Agenda item:	AH24 : High Speed Downlink Packet Data Access
Source:	Lucent Technologies
Title:	Technical Report text change proposal for Section 7.4.1
Document for:	Proposed text contribution for TR

Figure 1. Flat fading channel performance for 10.8 Mbps

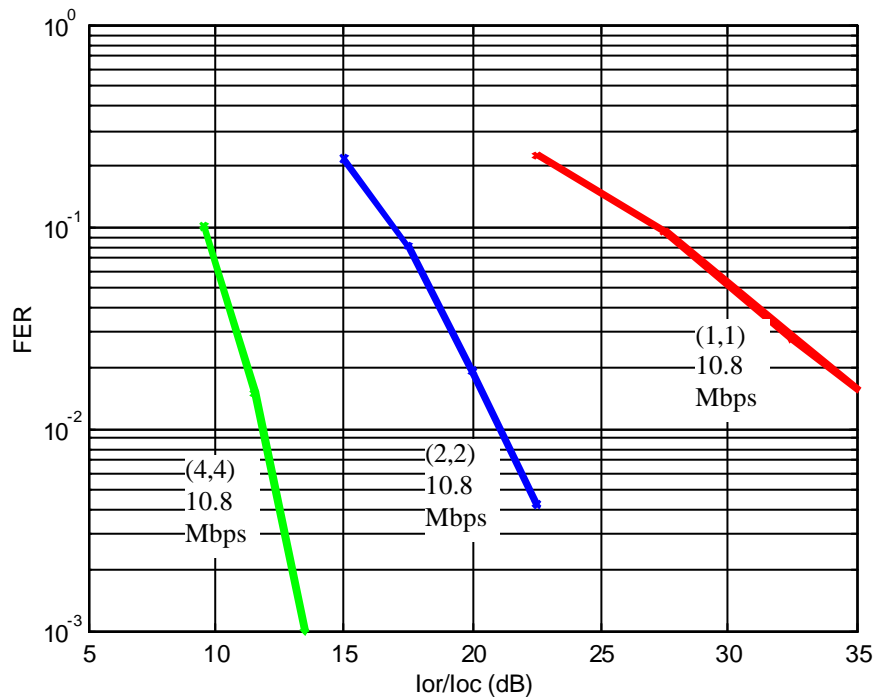
3. Replace the two performance figures showing FER versus Eb/N0 with the following corresponding figures showing FER versus Ior/Ioc.
